Product Change Notification

Change Notification #: 114315 - 01

Change Title: Intel® Server System R1304WT2GS ,
Intel® Server System R1208WT2GS ,
PCN 114315-01, Product Design,
Multiple chassis changes,
**Reason for Revision: Additional
products added to affected product list**

Date of Publication: January 07, 2016

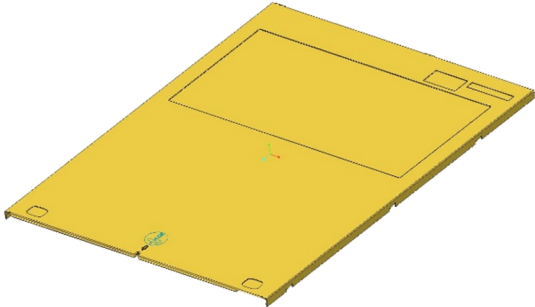
Change item	Pre-change	Post-change	Images
<p>Front / Rear TABS 4X 9.59 WAS 9.89, 4X 8.09 WAS 8.39.</p> <p>Move 2 X Small Rear Emboss 10.5 mm toward Front side</p>	H17525-005	H17525-006	
<p>Add 4X dimples at top side change tolerance from $\pm 0.5\text{mm}$ to $\pm 0.25\text{mm}$ for height 85.10mm</p> <p>Dimension; adjust right side thumb screw hole location from 11.21 to 11.65mm</p>	H29622-003	H29622-003	
<p>Dimension change 26.58 to 26.93</p>	H17966-004	H17966-005
